APICAL INDUSTRIES, INC.
dba DART AEROSPACE

ENGINEERING CHANGE NOTICE NO.

05110

DWG TITLE: STRUT ASSY

DWG NO. 647.7700

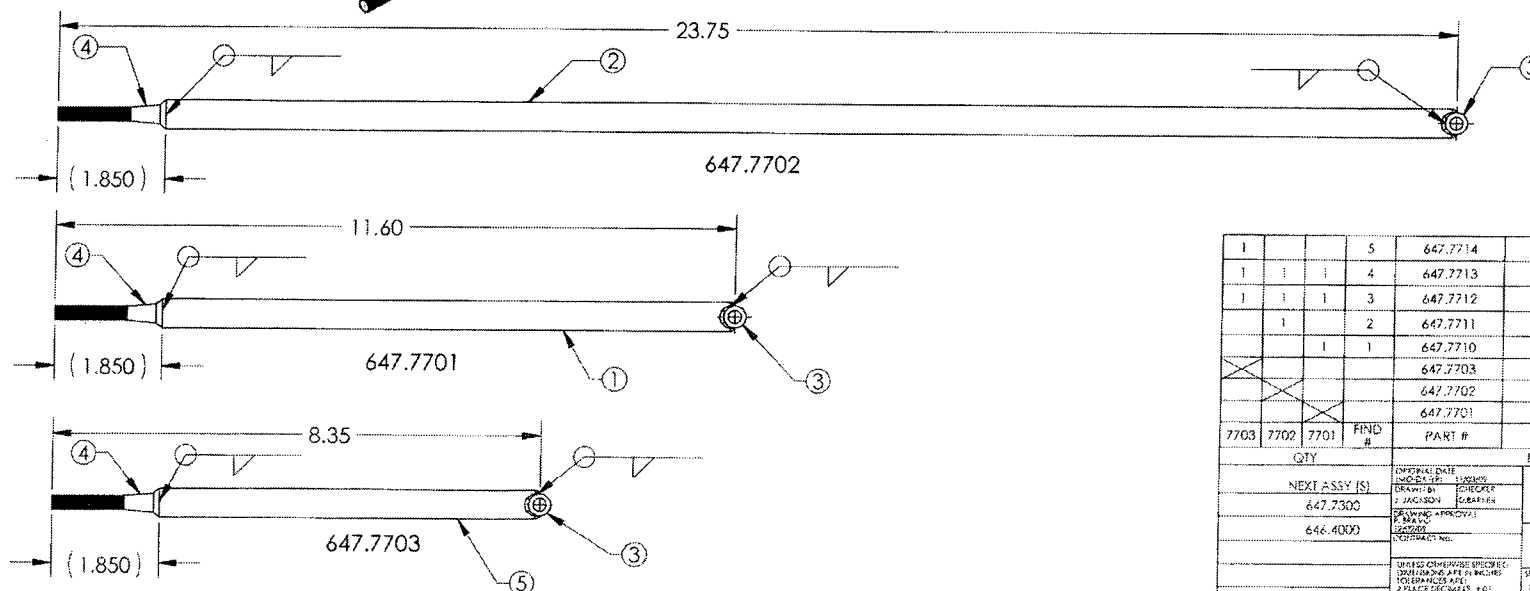
REASON: REVISED FINISH CALLOUT AS PER ECR 15-209

SHEET 1, NOTES IS:

- 1 MATERIAL: 4130 STEEL PER AMS-T-6736, .50" OD, .083" WALL THK.
- 2 MATERIAL: 4130 STEEL PER AMS-T-6736, .375" OD, .075" WALL THK.
- 3 MATERIAL: 4130 STEEL PER AMS-T-6736, .324" OD.
- 4 FINISH: PRIME IAW MIL-P-2337J TYPE I CLASS N; 1-2 MIL MAX
5. DEBURR AND BREAK ALL SHARP EDGES
6. IDENTIFY IAW MPP-120.
- 7 WELD IAW MIL-STD-2219, TIG WELD WITH FILLER ROD
- 8 FINISH: CAD PLATE IAW QQ-P-416F CLASS I TYPE II
- 9 MASK THREAD PRIOR TO FINISH

ACTION: UPDATE MO & WO
